Gulf Knitting & Textile Ltd

28th January 2015

Observations

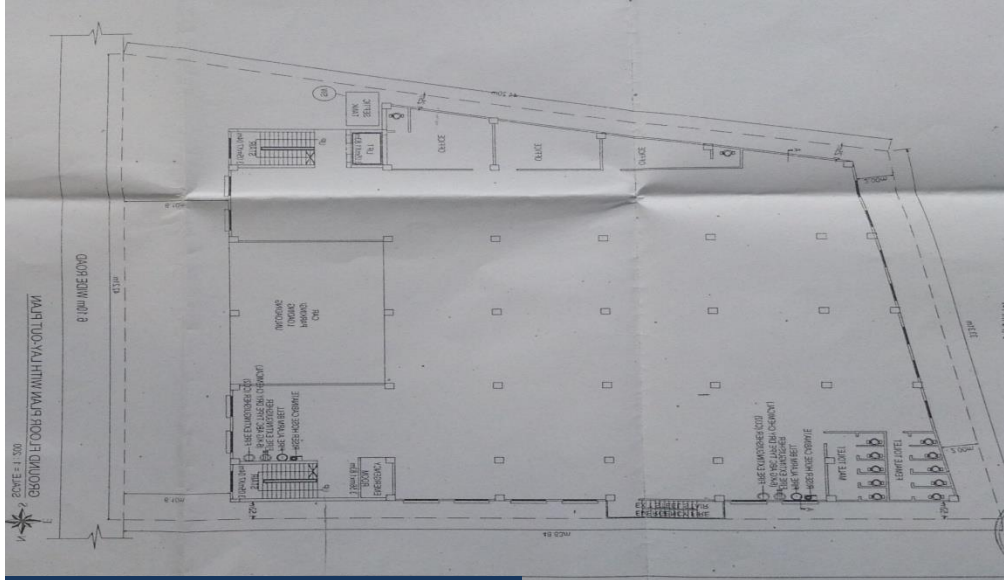
Large cantilever to front elevation at 3rd Level and above. Sagging of slab noted between cantilever beams

Cantilever at south elevation. Cantilever beam does not go to end. Only slab supports facade for last 300mm of cantilever.

Structural Drawing (Typical Floor Plan)

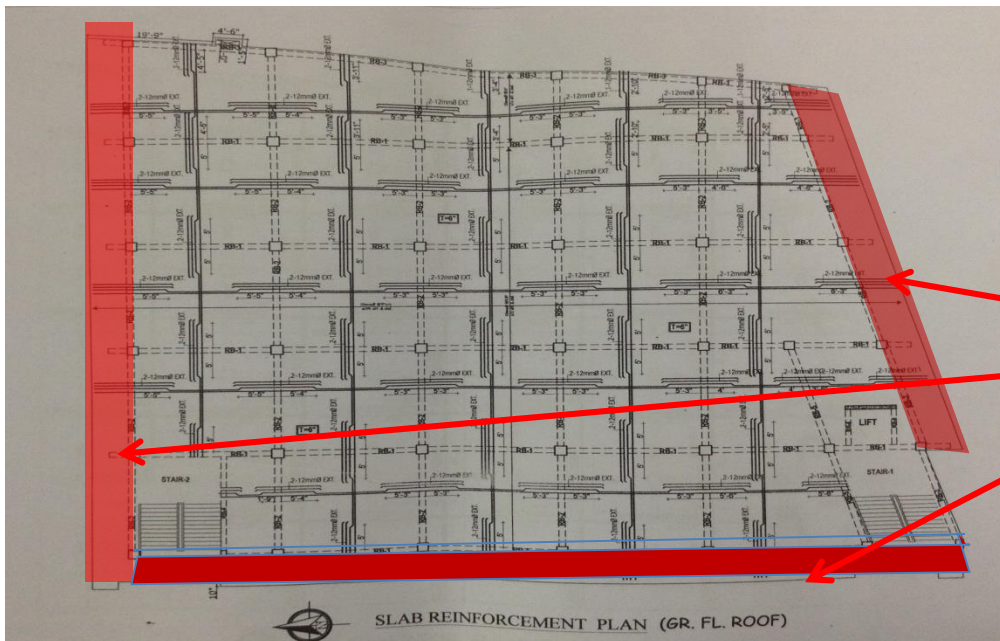
Permit Drawings different from Structural drawings:

- No cantilevers shown on permit drawings
- Number of bays different between permit and structural drawings
- Stairs layout and location different in both sets of drawings
- Structural drawings substantially reflect structure as built

Cantilever portions not shown in permit drawings for Levels 3 & 4
